6. CASE 24.078, 66 COOKE STREET, Donald E. Jackson House, c1925-35 (POWER-COOKE)

Proposal: The scope of work proposed consists of Major Alterations and includes:

Project: Single Family Residence
Address: 66 Cooke Street, Providence, RI 02906
Date: 8 July 2024
Re: Application Information

PHDC SUBMISSION

WINDOW ELEVATIONS

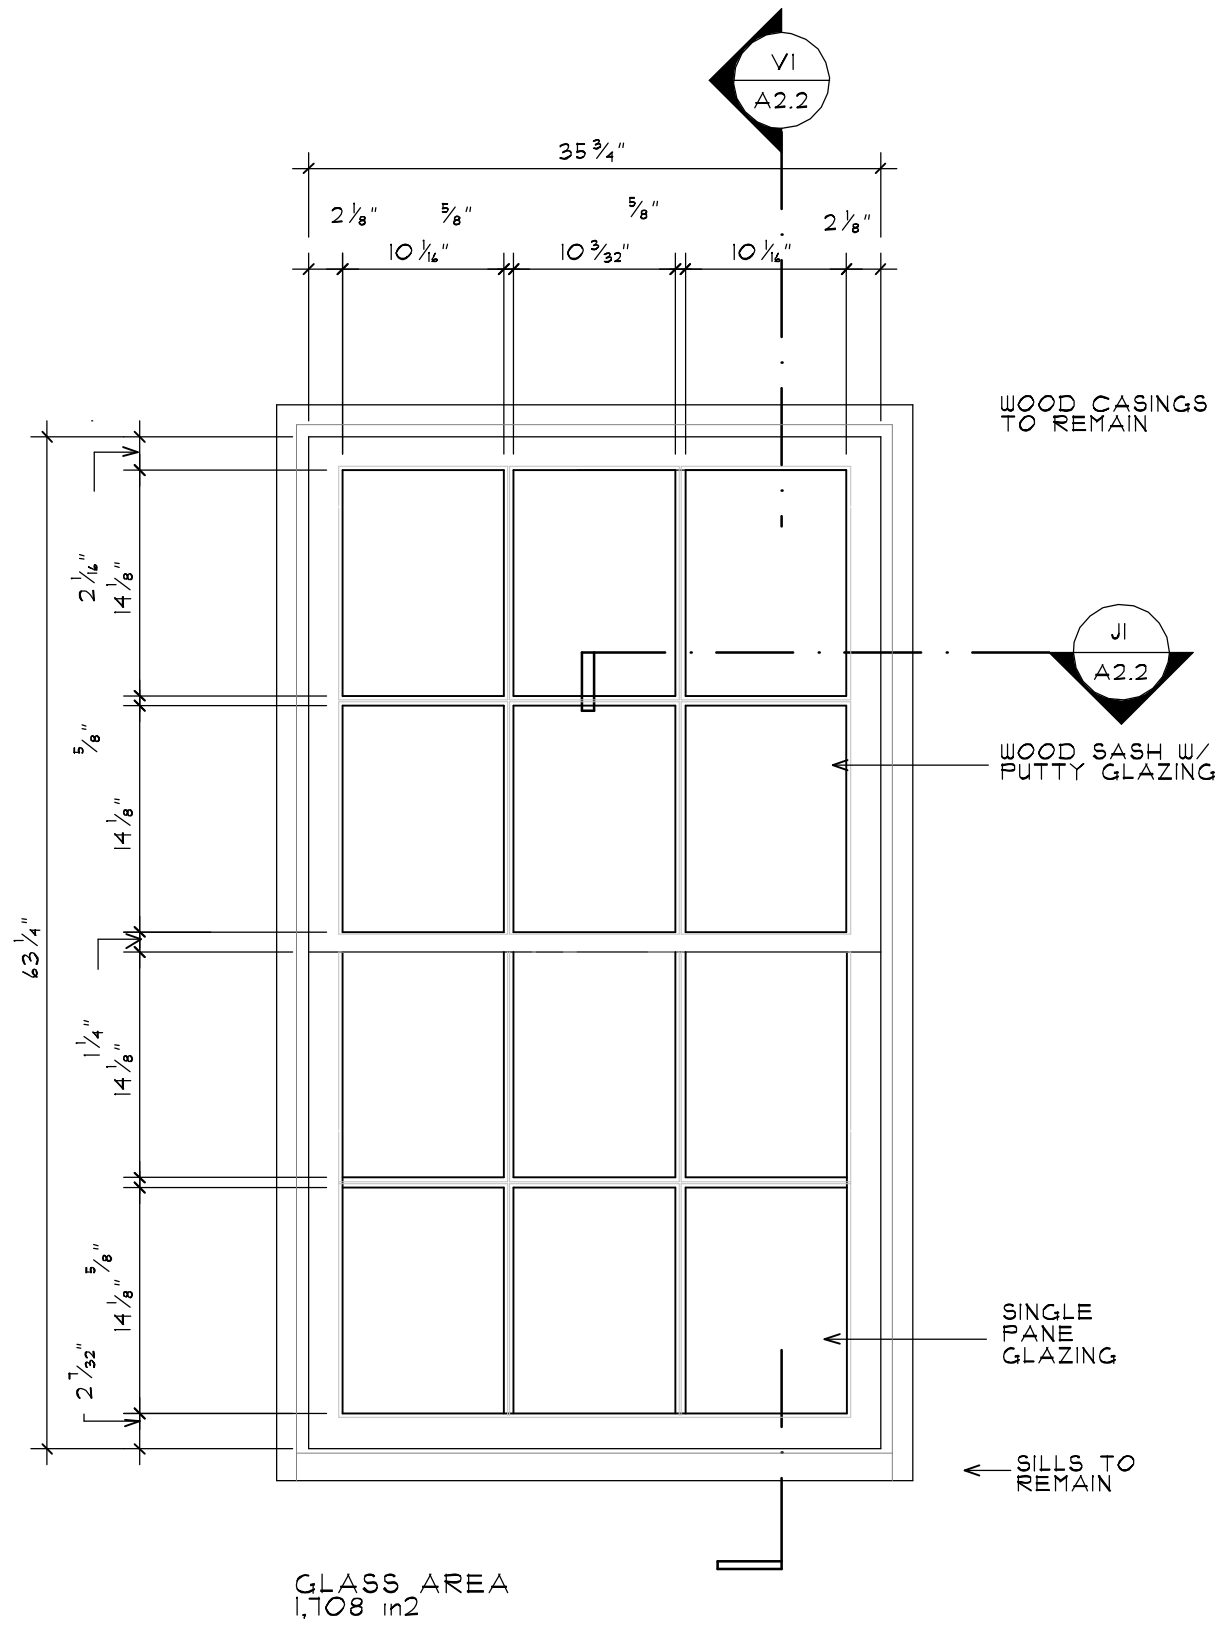
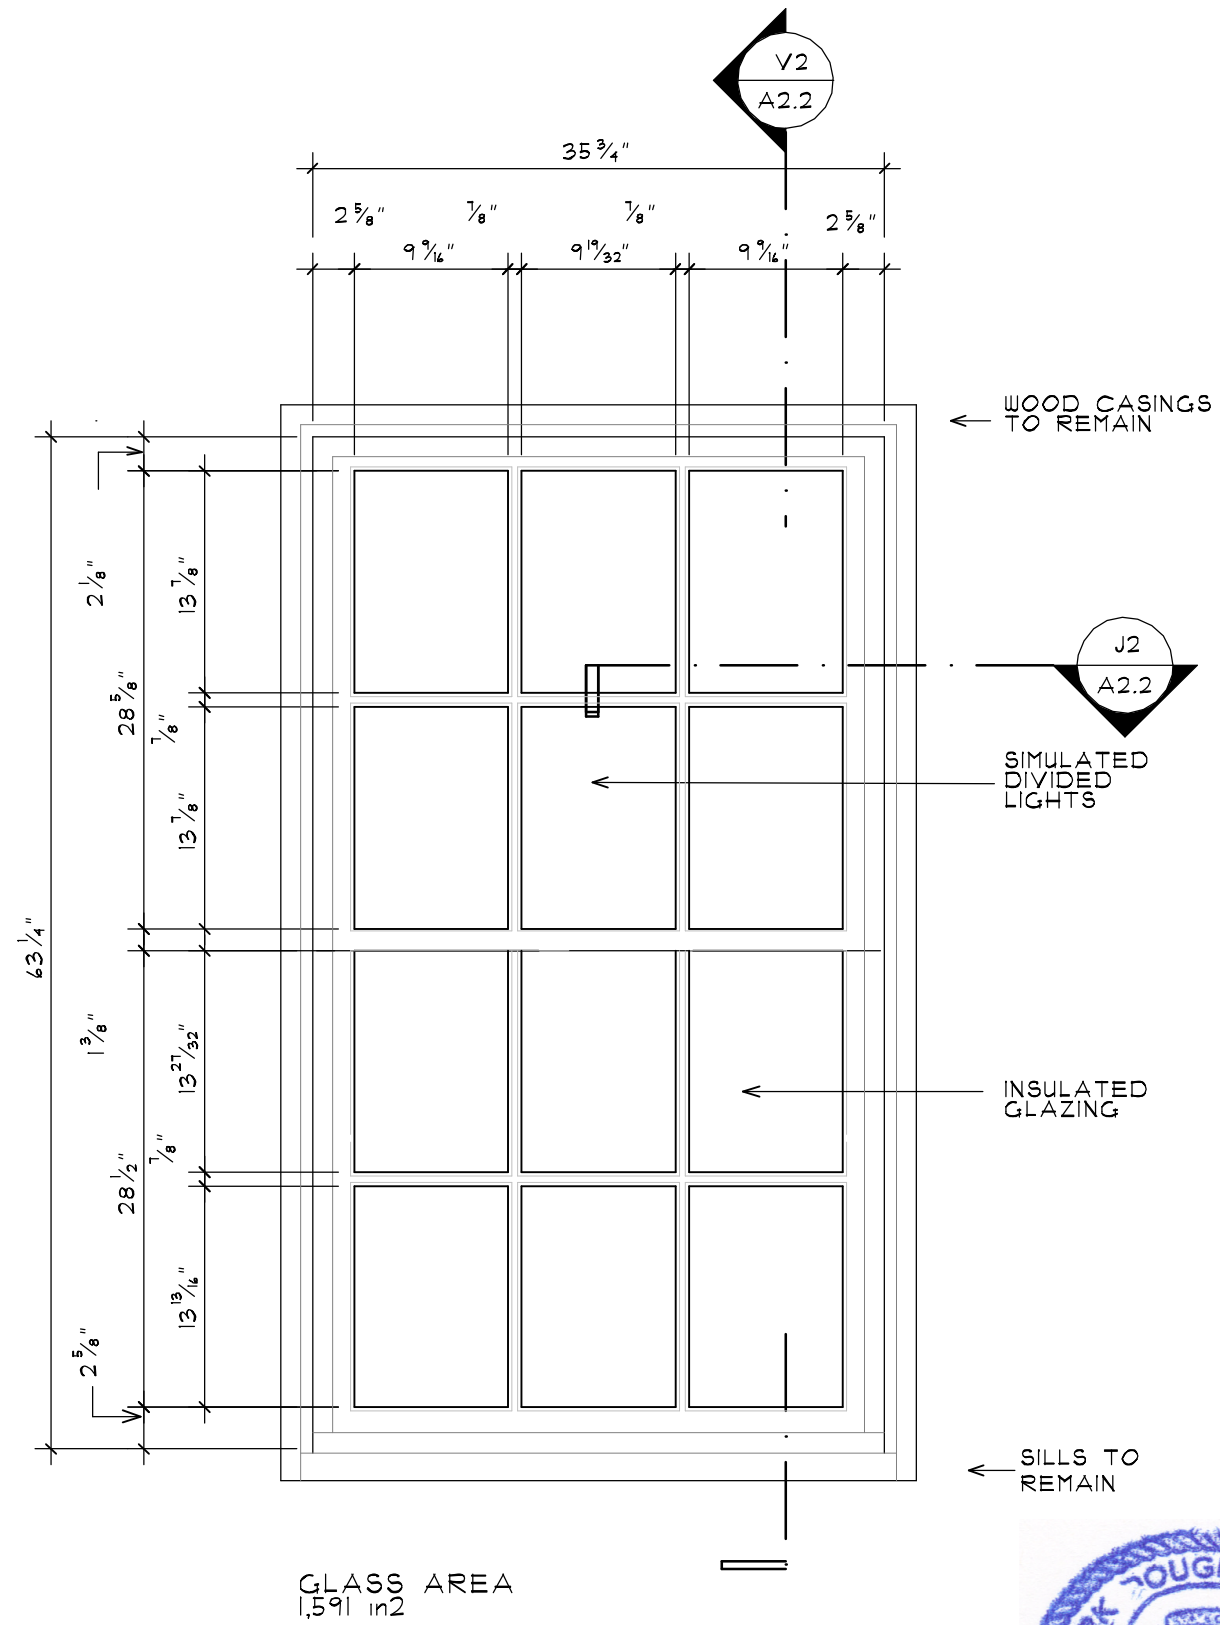
- Aesthetics – The Owner is willing to install replacement window sashes which are nearly identical to the existing. The muntin size and spacing will be matched. The difference in glass area reduction is 7% for unit “A”. The exterior, the new sashes, along with removal of the storm windows, will result in windows which are close to the original in size, function, appearance and profile depth with windows within the wall plane, which is diminished by the storm windows.
- Energy Efficiency – The new sashes, with insulated glass, and more efficient jamb liners and function are an improvement in air infiltration and U-value over the existing single pane windows with storm windows. The existing storm windows have weep holes at the sill which allow air to enter the building. Also, the weight pockets are to be filled with spray foam insulation to complete the envelope insulation

- b) The application for Major Alterations is considered complete; and,
- c) The work as proposed is in accord with PHDC Standards 2 & 8 as follows: the proposed alterations are appropriate having determined that the proposed construction will be similar in size and appearance to the existing, matching in visual features (Standard 2) and is architecturally and historically compatible with the property and district having an appropriate size, scale and form that while diminishing the historic quality of the property will not have an adverse effect on the property or district (Standard 8) while allowing the property to come into compliance with RIGL § 42-128.1-8.
